COMMENTS WITH REGARDS TO THE PROPOSED AMENDED LAYOUT OF THE RICHARDS BAY COMBINED CYCLE (CCPP) POWER PLANT AND ASSOCIATED INFRASTRUCTURE NEAR RICHARDS BAY, KWAZULU-NATAL PROVINCE (REF NR: SE1655)

RE: COMMENTS WITH REGARDS TO THE AMENDED LAYOUT PROPOSED FOR THE RICHARDS BAY COMBINED CYCLE (CCPP) POWER PLANT AND ASSOCIATED INFRASTRUCTURE NEAR RICHARDS BAY, KWAZULU-NATAL PROVINCE (REF NR: SE1655)

PROPOSED RICHARDS BAY COMBINED CYCLE POWER PLANT (CCPP) PROJECT IN RICHARDS BAY, KWAZULU-NATAL PROVINCE - REVIEW OF VISUAL IMPLICATIONS OF PROPOSED LAYOUT AMENDMENTS DETAILED ON SITE LAYOUT DRAWING 0.103/00010 REV 2

**ADDENDUM TO THE QUANTITATIVE RISK
ASSESSMENT FOR THE PROPOSED RICHARDS
BAY COMBINED CYCLE POWER PLANT NEAR
RICHARDS BAY, KWAZULU-NATAL PROVINCE**

APPENDIX A – AMENDED LAYOUT

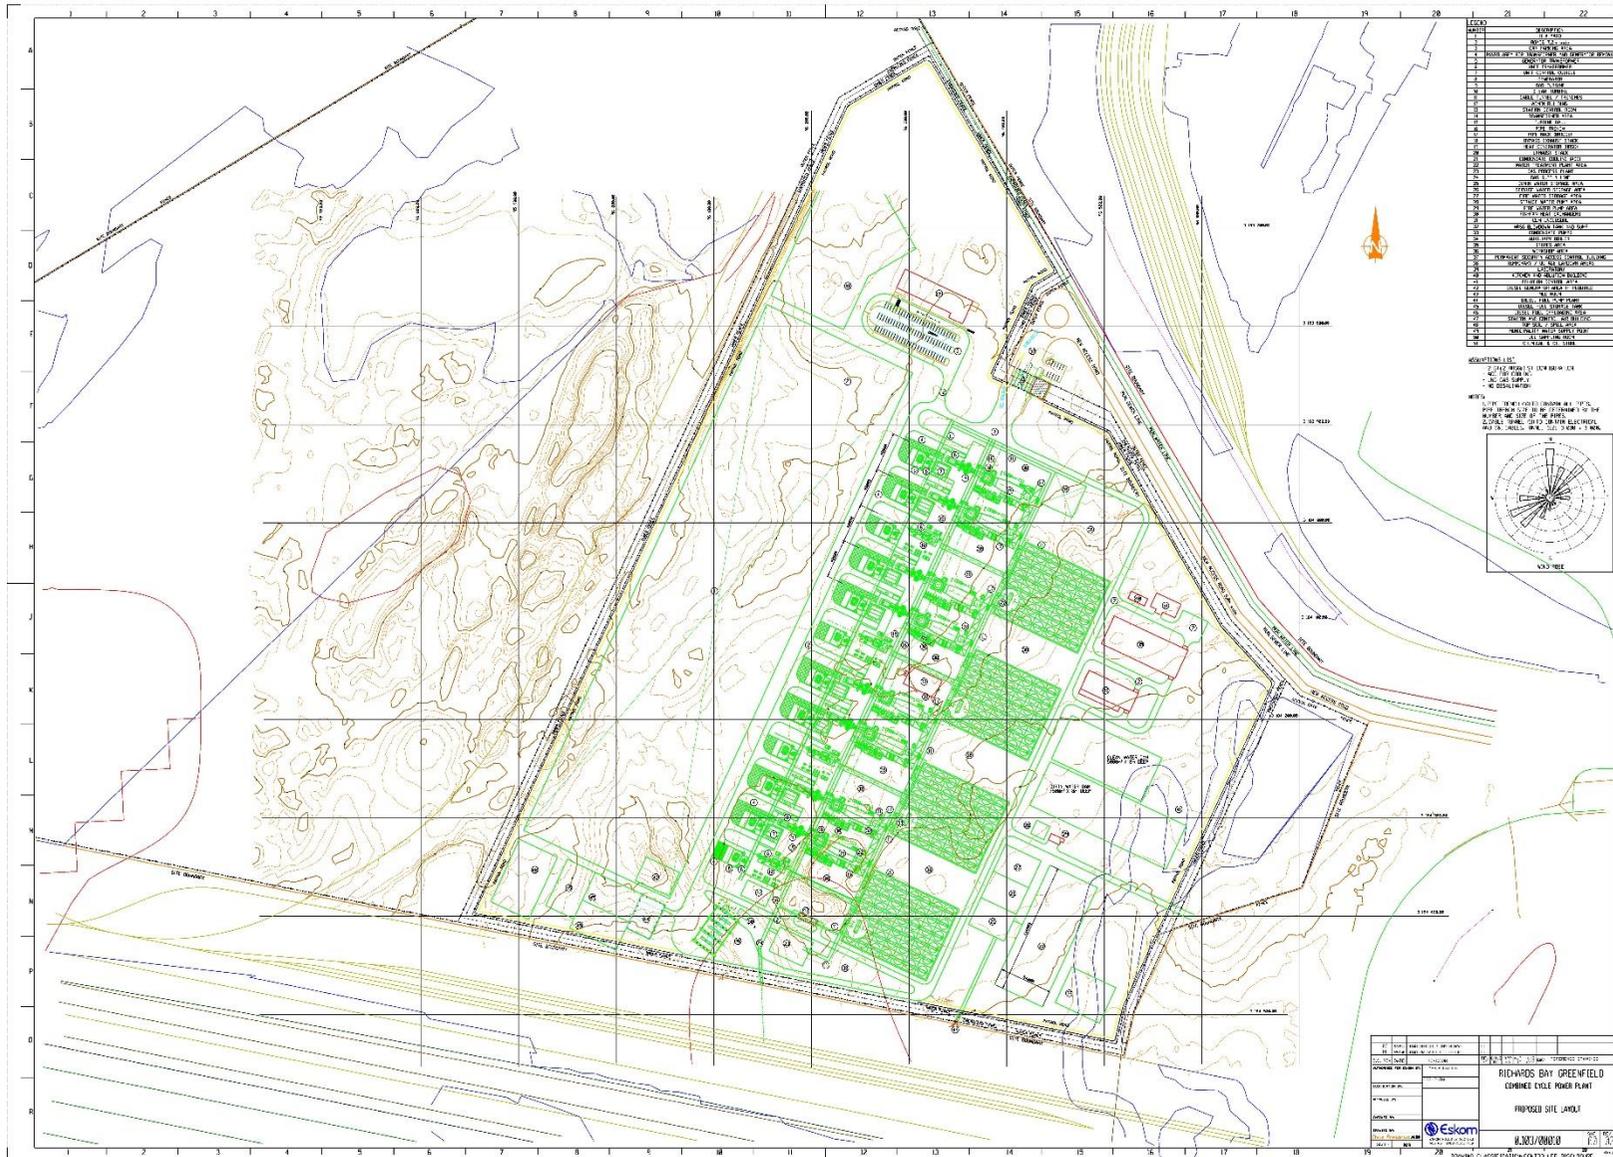
Further to our recent discussion and receipt of the above mentioned drawing, I confirm that I have compared the proposed amended layout (Appendix A) with the layout that was assessed as part of Landscape and Visual Impact Assessment (February 2019) (Appendix B).

From the comparison of the originally assessed layout and the proposed amended layout, the location of major elements relative to each other remains consistent with the assessed layout considered as part of the Landscape and Visual Impact Assessment

Given the scale of the proposed development, the proposed amendments to the layout will not result in any change in the areas from which the proposed development is likely to be visible (Zone of Theoretical Visibility Map 7 of the Landscape and Visual Impact Assessment).

The amended layout will also not change the location or the extent of the view that the proposed development will occupy as indicated on Plates 15 to 24 inclusive within the Visual Assessment Report.

In addition to the nature of the existing landscape, the factors noted above are critical to the assessment of visual impacts. We are therefore confident that the assessment included in Section 5 of our report will not be affected by the proposed amendment and the proposed mitigation measures are still considered acceptable for the amended layout. No additional mitigation measures will be required.

Figure 2 – May 2019 Amended layout for the CCPP.

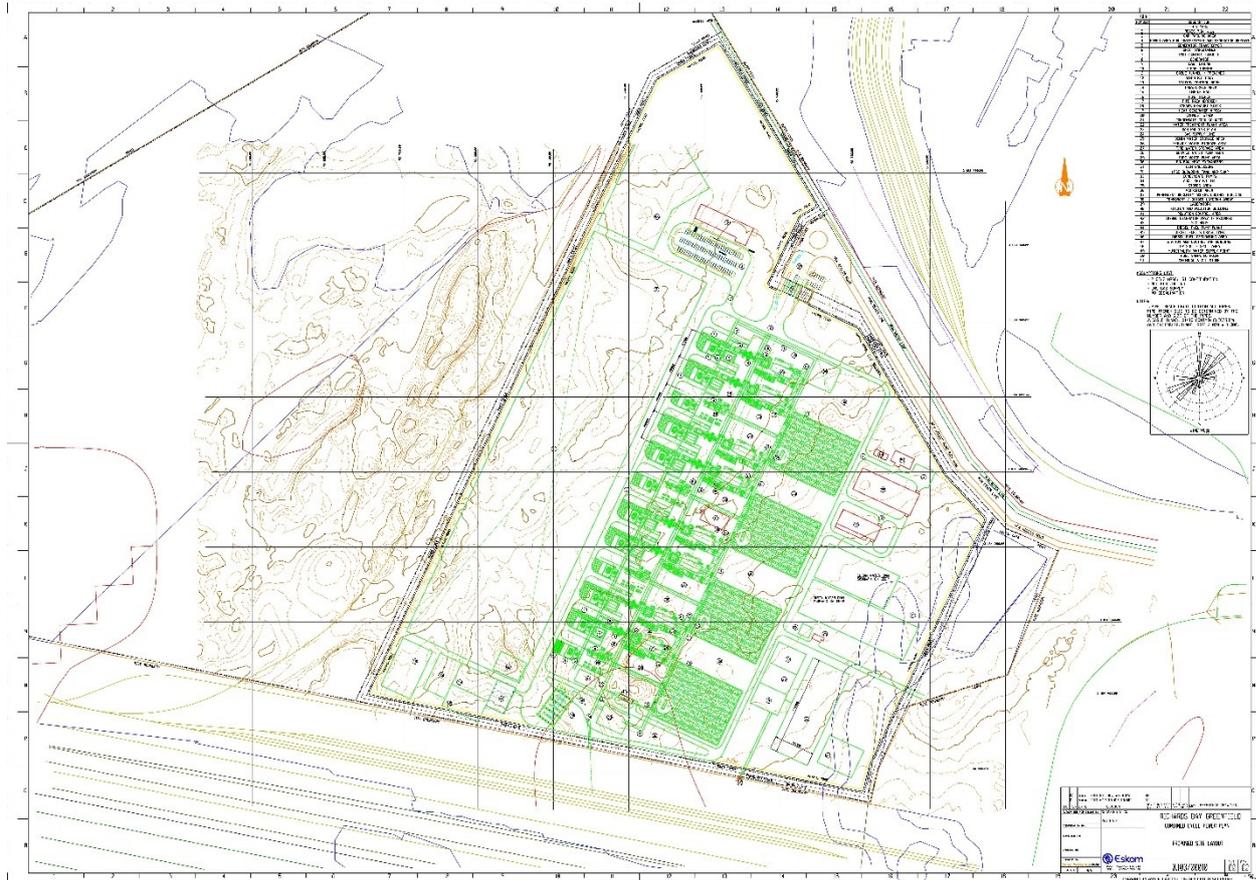
The proposed CCPP site boundary has since been amended (reduced in size) as shown in **Figure 2** below.

The change in the layout does not impact on the proposed CCPP, nor does it impact on the site access, expected traffic generation, and environmental assessment as contained in the Traffic Impact Assessment Report for the proposed CCPP Power Plant, Richards Bay, KwaZulu-Natal – February 2019 – Techso (Pty) Ltd.

1. The TIA Report dated February 2019 remains valid and that the amended layout, as shown in **Figure 2** of this report, has no impact on the conclusions and recommendations of the TIA dated February 2019.
2. The mitigation measures included are sufficient for the implementation of the amended layout and no additional measures are required.
